Bramford to Twinstead Reinforcement

**Document 8.9.5 (C): Temporary and Permanent Access Technical Note
– Suffolk County Council**

**Final Issue C
February 2024**

Drawing title
**AB-AP5: Church Hill, north of Burstall
 Proposed Visibility Splay
 Concept Design
 Sheet 1 of 1**

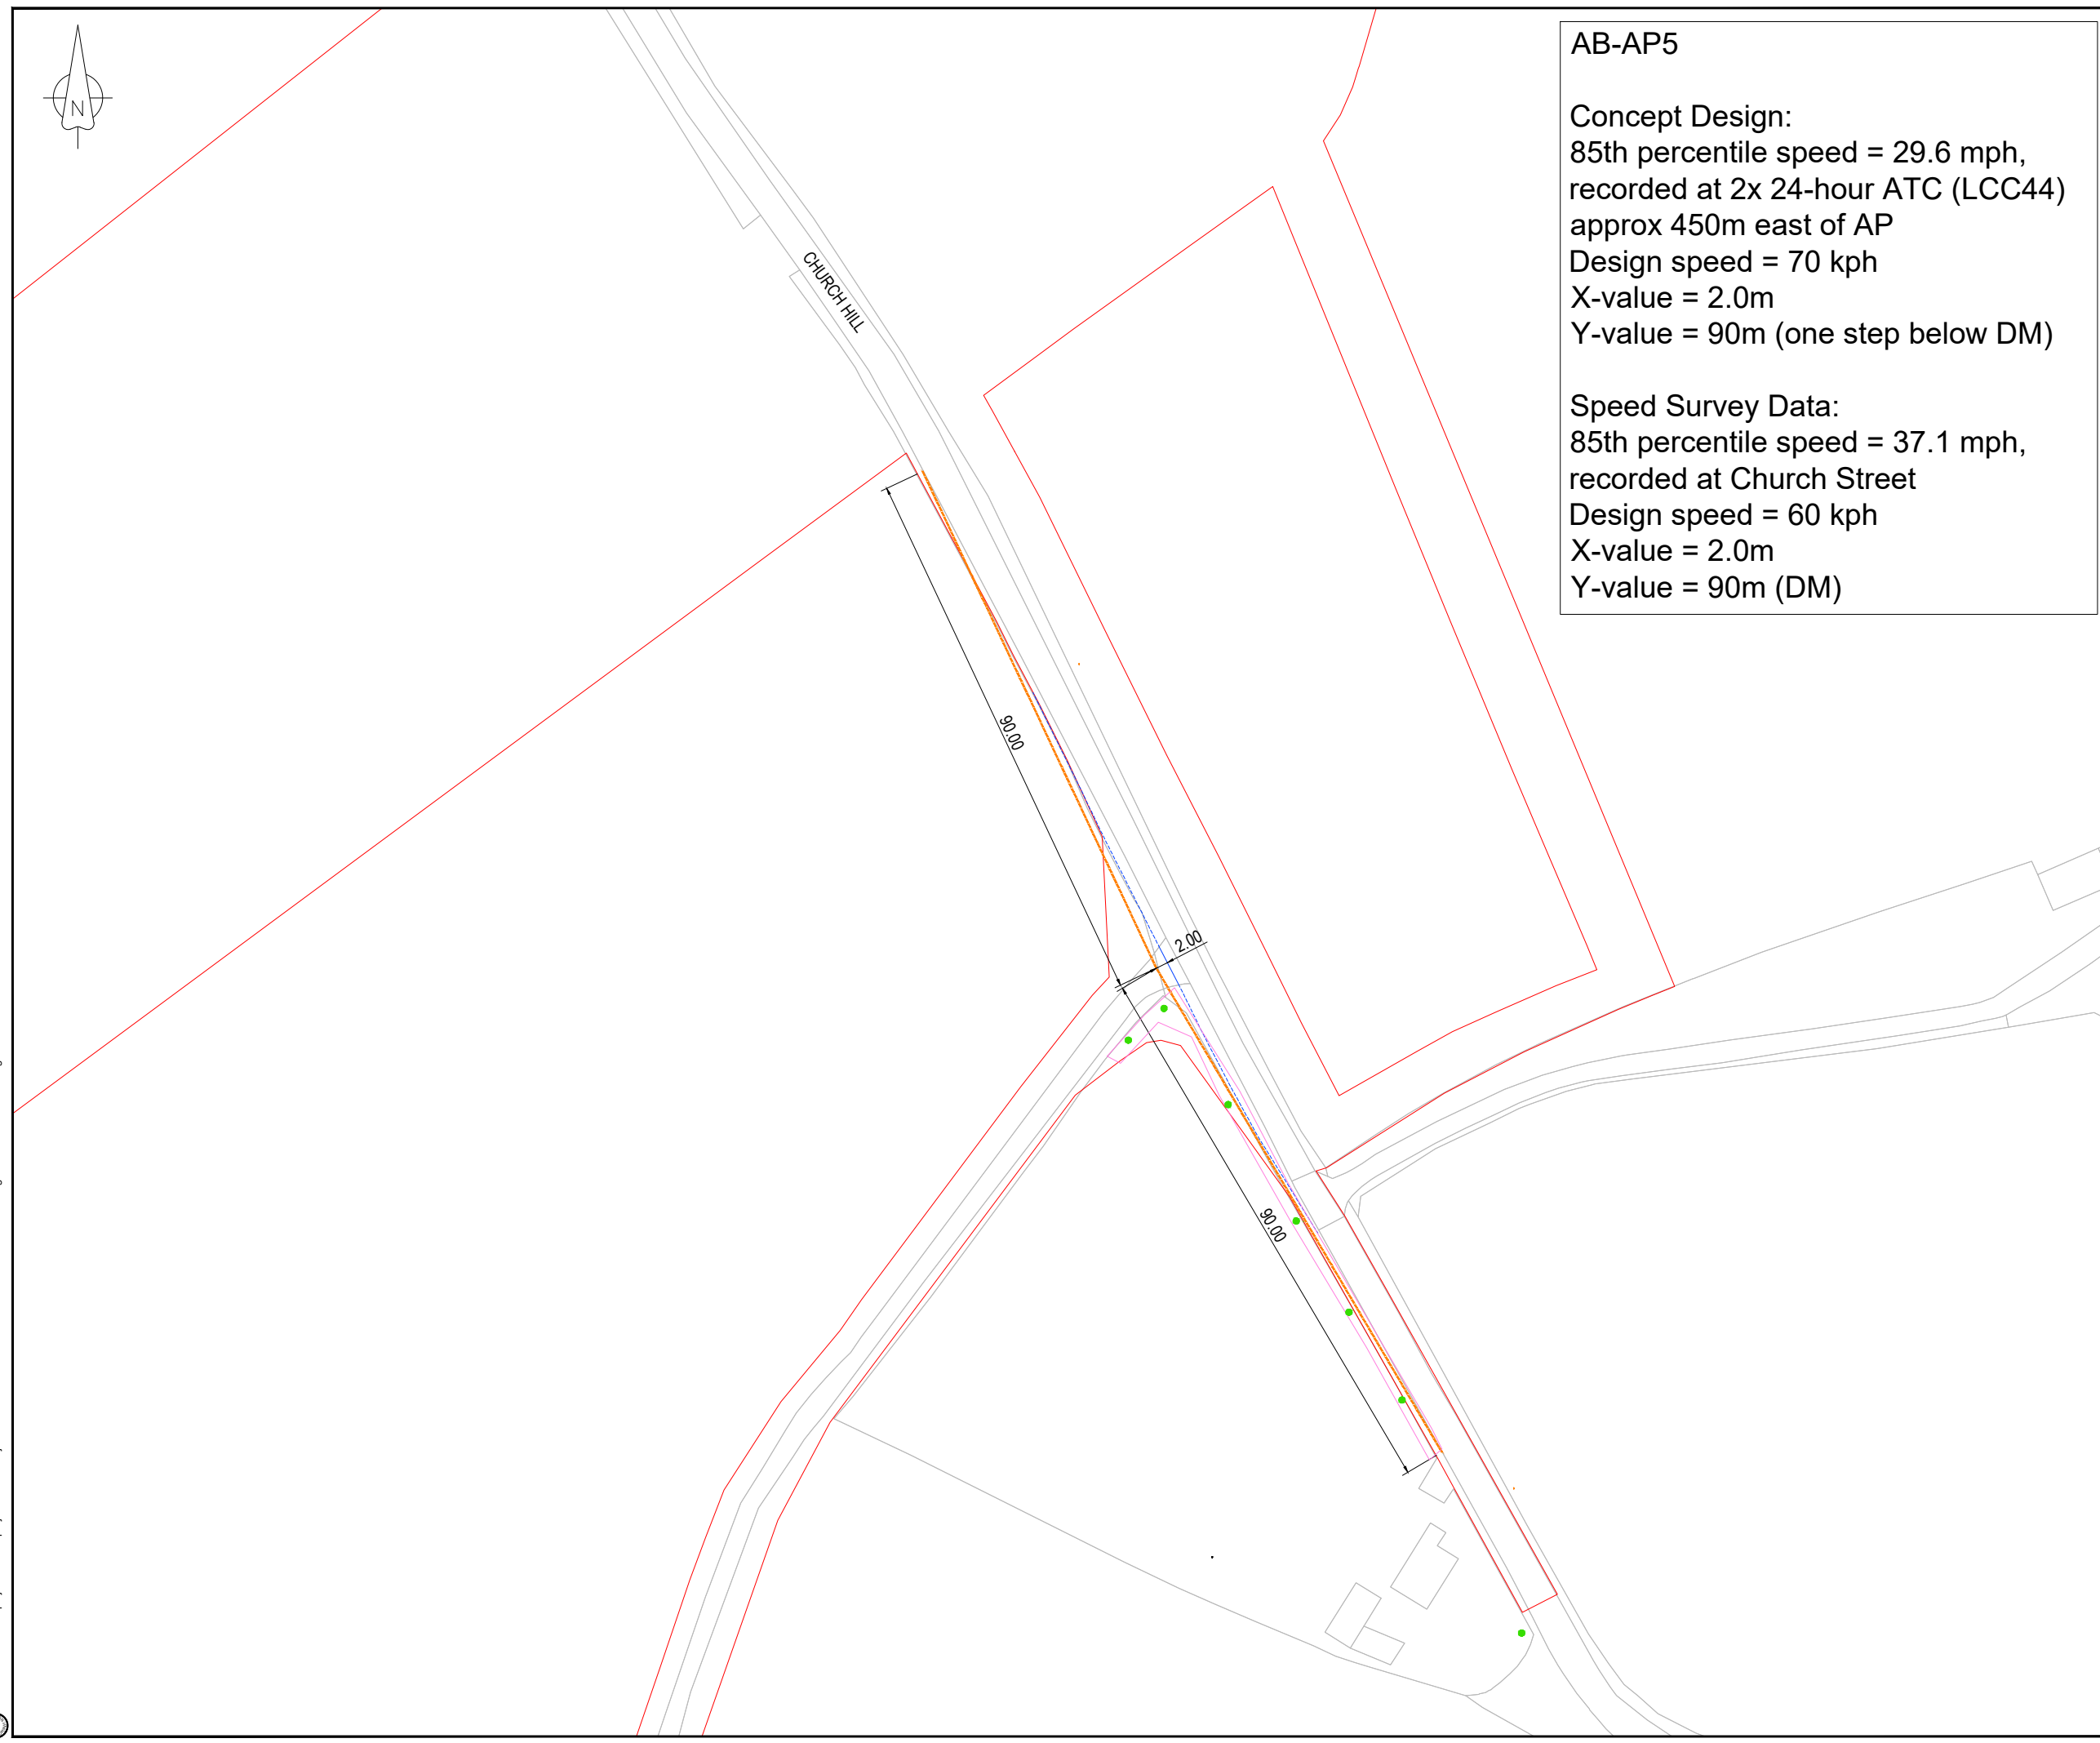
- 2.1.3 AB-AP5 is located north of a bend in the road, which is considered likely to reduce vehicle speeds at the access point and means that visibility to the south of the access point is limited primarily by the curvature in the road rather than by vegetation. The Applicant has drawn a visibility splay based on nearby traffic survey data, indicating that 70kph is the expected upper limit of the 85th percentile design speed, yielding a y-value, or distance along the major route of 90m (one step below the desirable minimum stopping sight distance). The Applicant has also considered the National Highways Design Manual for Roads and Bridges (DMRB) CD 123 – Geometric design of at-grade priority and signal-controlled junctions cl. 3.8, and proposes a x-distance of 2m which is appropriate for direct accesses. The x-distance is the distance away from the carriageway edge where the viewpoint of a driver of an emerging vehicle is positioned.

- 2.1.7 The Applicant has carried out a topographic survey in this location, which has determined that Church Hill widens in the vicinity of the existing private access. However, by maintaining the existing carriageway width of approximately 4.8m south and north of the junction by way of an edge-marking solution, the driver's eye position can be brought further down the access track towards Church Hill itself. This will essentially formalise the existing situation, where the carriageway extends towards the access track but the delineation point between Church Hill and the access track is the extension line of the edge of carriageway either side of the access.

- 2.1.8 The Applicant has also undertaken a detailed arboricultural survey of the trees at AB-AP5 Church Hill, to inform the vegetation loss assumptions. This identified seven trees and one group. Six of these are mature oak trees of moderate value, the majority of which contain deadwood (over 75mm diameter) and prolific ivy on the main stems and into the mid canopies. Located in close proximity to the proposed bellmouth is a semi-mature ash tree categorised as being low in value. The tree group is also categorised as low in value and contains a mixture of broadleaf tree species previously managed as a hedge. Species include hazel, field maple, elm, hawthorn and oak, the group contains standing dead elm stems. The outcome of the arboricultural survey is shown in the Arboricultural Impact Assessment (**document 5.10 (C)**) at Deadline 9.

~~2.1.82.1.4~~ A speed survey was commissioned in January 2024 at this location to confirm the 85th percentile design speed assumption was appropriate. The speed survey was carried out at this location because the data collected previously was not sufficiently close to the access and as a result of concerns raised about this access in particular during Examination of the application. Speed survey data obtained for the project prior to submission of the application is provided in document 8.9.2 Transport Assessment Traffic Survey Data [REP7-024]. The survey was undertaken at Church Hill, in the vicinity of the access point, for a seven-day 24-hour data collection starting 10 January 2024. Table 2.1 shows the outcome of the speed survey.

~~2.1.92.1.5~~ The design at application was based on a design speed of 70kph based on the 85th percentile design speed from the previous traffic survey, and a 90m stopping sight distance, which is one step below the desirable minimum. The recent speed survey revealed that the design speed based on the 85th percentile is 60kph, which is lower than the design speed assumed for the sketch in Appendix A. For a design speed of 60kph, 90m is considered the desirable minimum stopping sight distance. Therefore, the survey confirmed that the approach taken in Appendix A is appropriate and no modifications are necessary to the visibility splay in the concept design.

- 2.1.9 The visibility splay shown in Appendix A requires the coppicing and pruning of vegetation within the functional highway to achieve the dimensions set out above. It is anticipated that the ash tree (low value) would need to be removed from the entrance and the tree group (low value) would need coppicing to achieve the required visibility splays. The oak trees would not need to be removed, although the removal of ivy from the main stems would further improve visibility. It would also be prudent to remove deadwood from the oak trees where this overhangs the road for health and safety reasons.

- 2.1.10 The design developed shows that AB-AP5 is an appropriate access which would not require excessive vegetation removal. The AB-AP5 sketch on Appendix 1 has been updated to incorporate the position of the seven trees identified.

Drawing title: **AB-AP17, Pond Hall Farm
 Proposed Visibility Splay
 Concept Design
 Sheet 1 of 1**

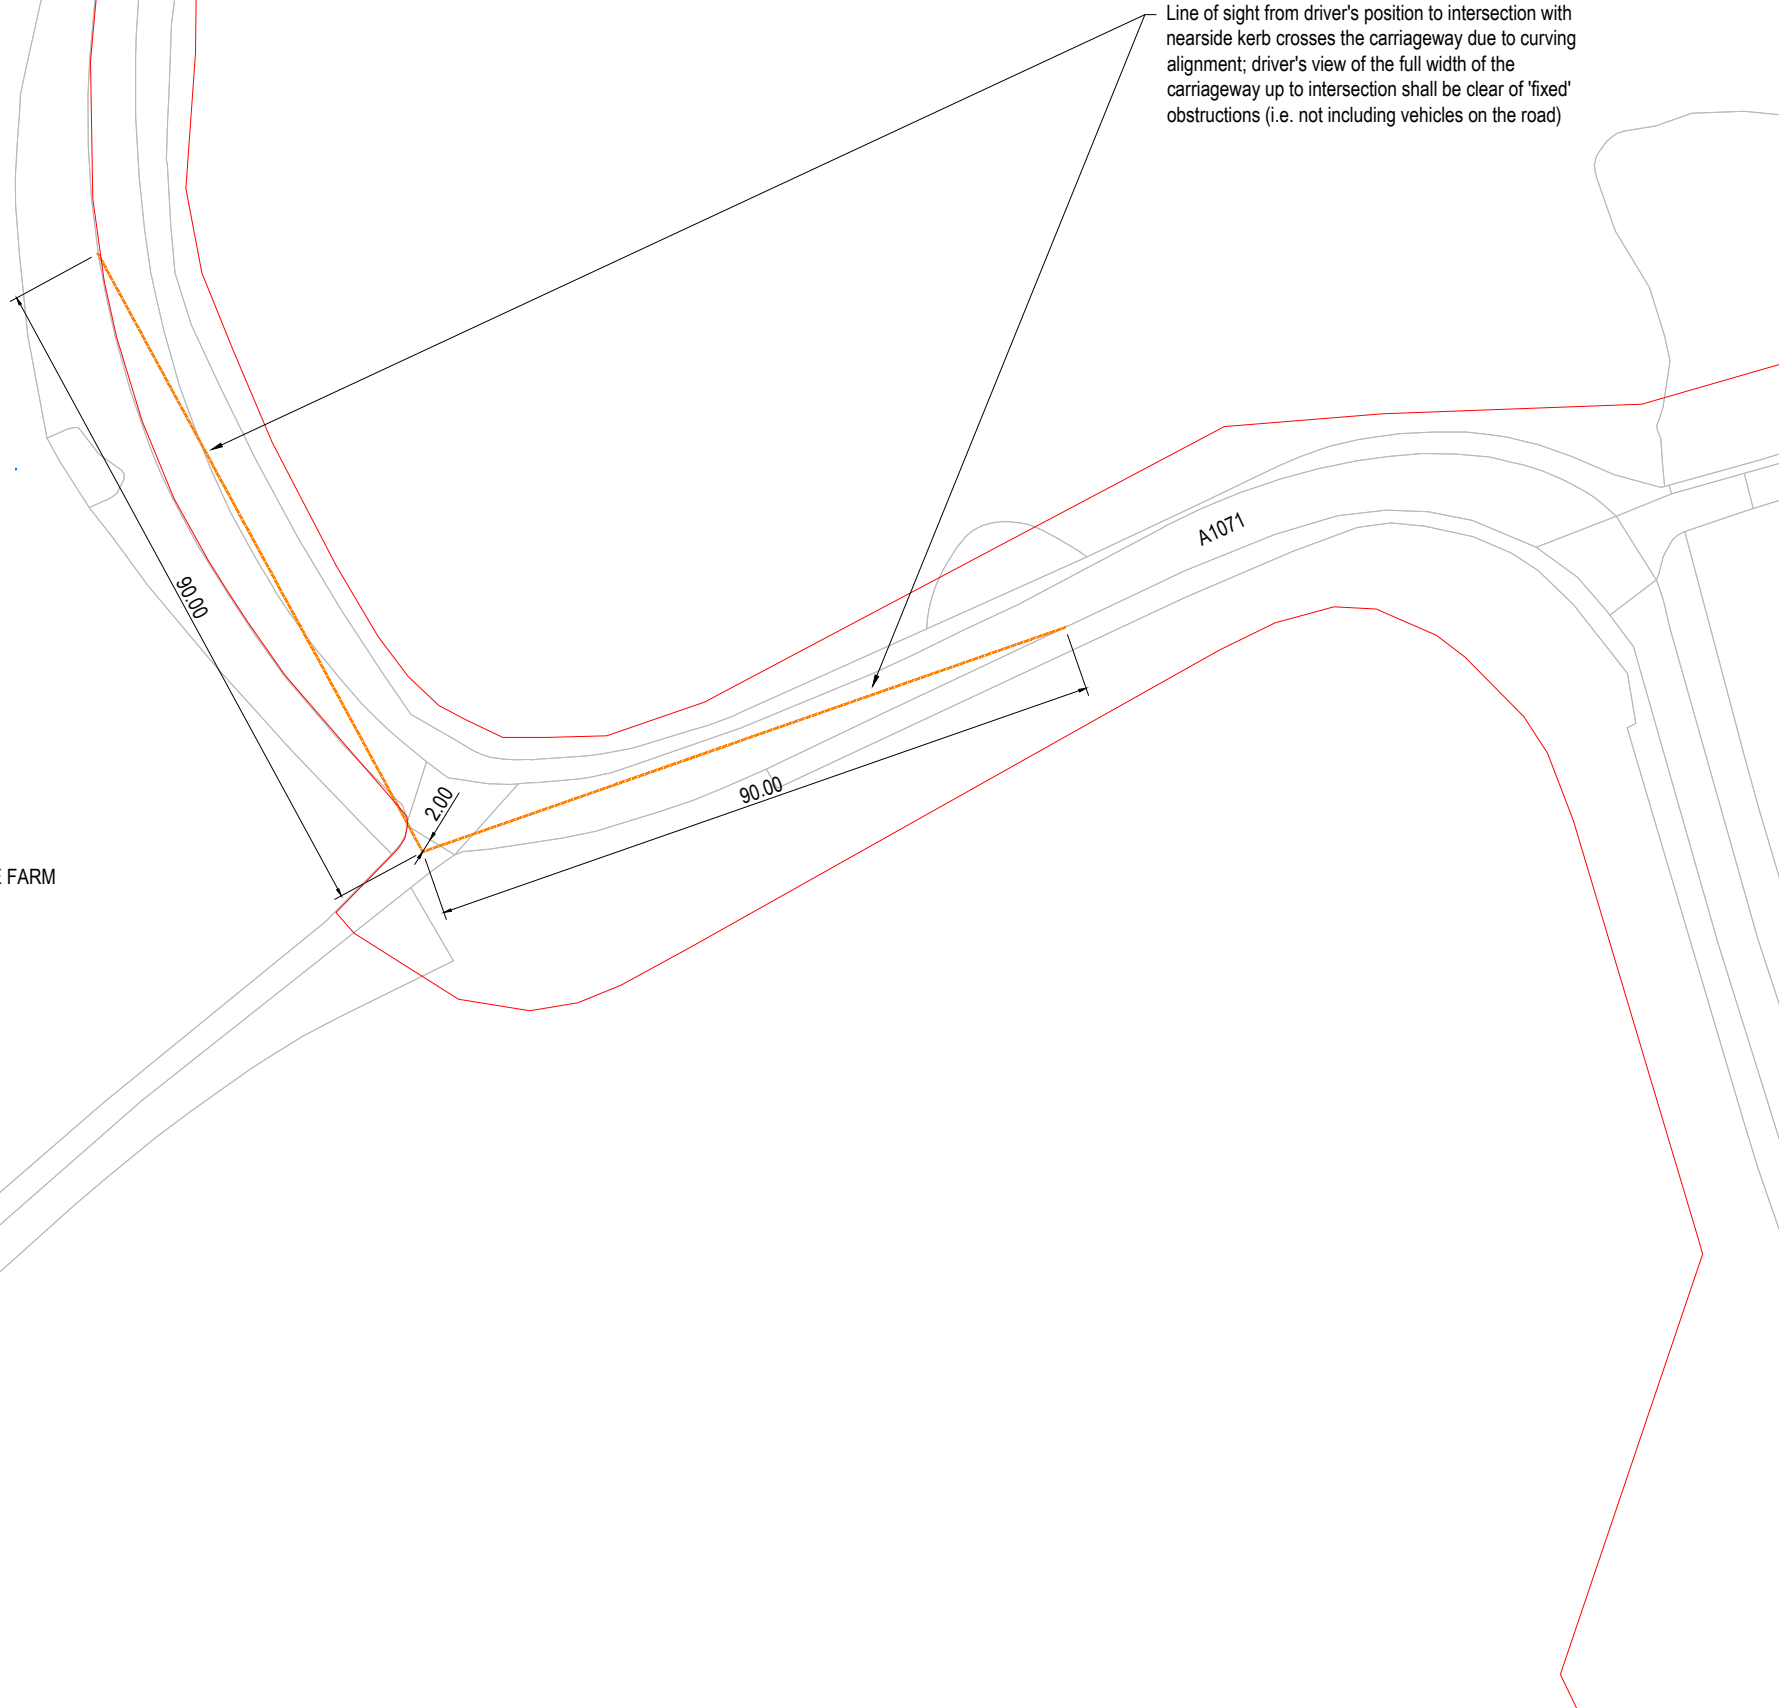
2.4.4 To achieve the proposed visibility splays it may be necessary to remove vegetation outside the Order Limits. Article 48 of the draft DCO (**[document 3.1 (G)(H)]**) provides the power to the Applicant to remove or manage vegetation ‘*under or within or overhanging or near any part of the authorised development*’ subject to certain provisions. Within the highway, this provision can only be exercised with the consent of the LHA. Therefore, the Applicant has the power to manage this vegetation should it be agreed with the LHA that this is the best approach. An alternative solution would be to use traffic management measures to reduce speed and therefore reduce the required visibility splays. These options would both be considered, potentially alongside others, and a preferred solution agreed with the LHA in the discharge of Requirement 11. However, the work completed to date shows that there are options available to develop a safe access in this location, it is only the detail of which option would be pursued that is not finalised at present.

2.4.5 Any vegetation removal would be part of the submitted package of approvals for LHA approval before the project progressed to construction in accordance with Article 48 of the draft DCO (**[document 3.1 (G)(H)]**). In addition, Requirement 8 of the draft DCO requires the approval of all vegetation to be agreed by the relevant planning authority prior to construction work commencing.
